CONDITIONS OF APPROVAL:

Engineering - Final Plat Checklist

12. C. Final Plat

*10' MVUD EXCLUSIVE WATER LINE EASEMENT —
DEED BOOK ____, PAGE ____, R.O.W.C*

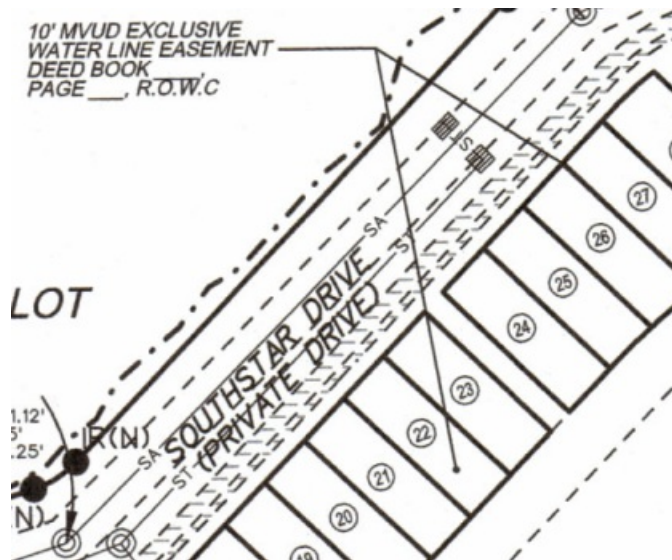
lance.fittro@franklin.tn.gov Prior to final approval for recording, applicant shall fill in the deed book and page number reference for the recording of the MVUD easement shown on the plat:

In addition, applicant shall correct the proposed MVUD easement call-out shown below such that it does not designate Lot 22 as an exclusive easement.

brad.thomas@bwsc.net Owner is working on recording this easement. It will be recorded prior to Mylar being prepared.
